Special Exception Application: 2520 HOMEWOOD DRIVE- GUEST COTTAGE WITHOUT A KITCHEN

Applicant Request: PURSUANT TO BELLE ISLE CODE SEC. 42-63 AND SEC. 54-75 (C) (5) THE BOARD SHALL CONSIDER AND TAKE ACTION ON A REQUESTED SPECIAL EXCEPTION TO ALLOW A GUEST COTTAGE WITHOUT A KITCHEN ON A SINGLE-FAMILY RESIDENTIAL PROPERTY WITH A PRIMARY DETACHED SINGLE-FAMILY DWELLING, SUBMITTED BY APPLICANT PROTEAM LLC, LOCATED AT 2520 HOMEWOOD DRIVE, BELLE ISLE, FL 32809 ALSO KNOWN AS PARCEL # 19-23-30-5888-06-122.

Review Comments

RE: JONES RESIDENCE
2520 Homewood Drive,
Belle Isle, Florida, 32809

SITE PLAN

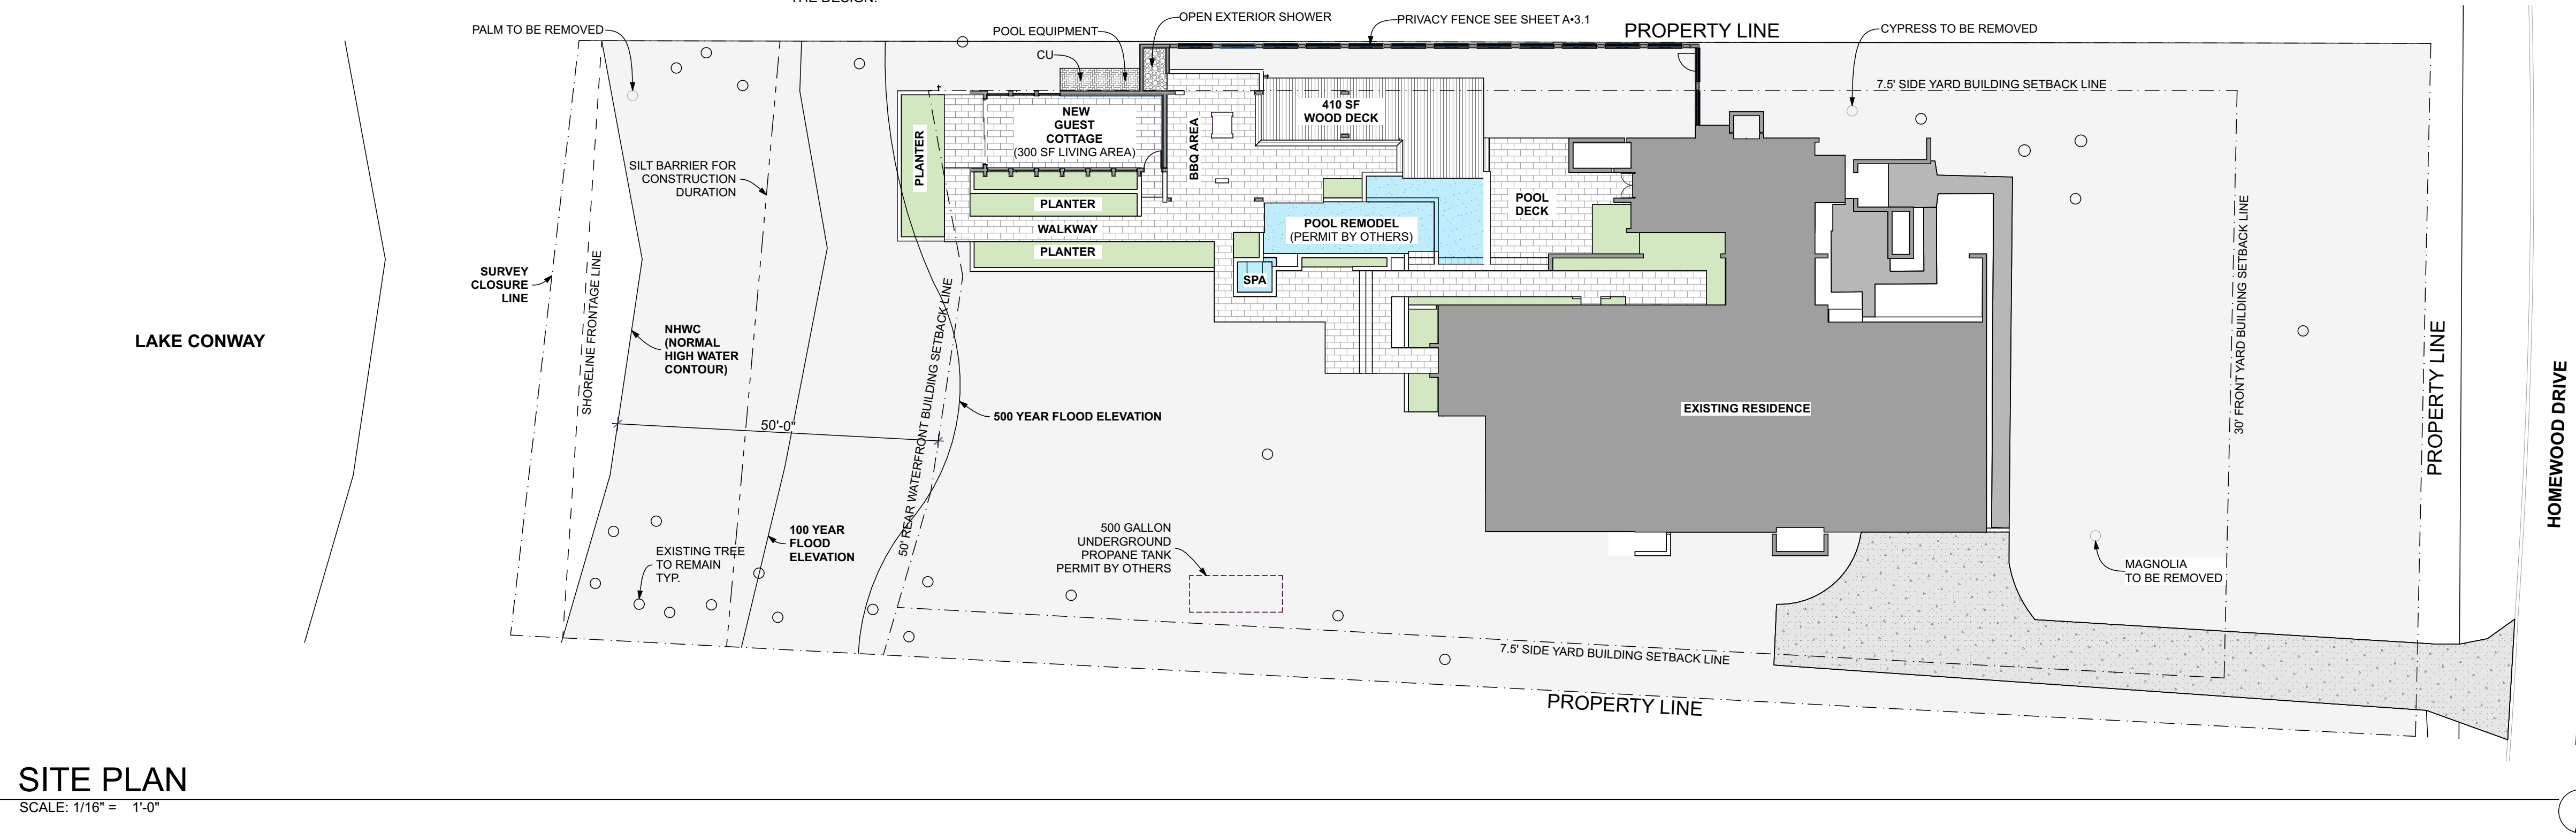
Although the application states that the requested guest cottage is to be 300 square feet, the plan set submitted identifies an area larger than 300 square feet that could be construed to be part of the guest

cottage (area encompassing the guest suite, through to the attached bathroom and closet). This area roughly equals 355 square feet. The code does not prohibit the Planning and Zoning Board from approving a guest cottage larger than 300 square feet. The Board must find that the public health, safety, comfort, order, convenience, prosperity, morals or general welfare is promoted, protected or improved.

2. The plans shall be revised to remove the proposed open exterior shower, BBQ Area and deck/patio areas (including the area for pool equipment) that are proposed to sit within the required 7.5-foot side setback area prior to submitting for building permitting. The deck/patio areas must meet an accessory building/structure 5-foot setback requirement from the side property line and the open exterior shower and any vertical structures in the BBQ Area and Wood Deck area must meet the 7.5-foot setback since these are attached to the guest cottage pursuant to Sec. 50-102 (a) (2); and,
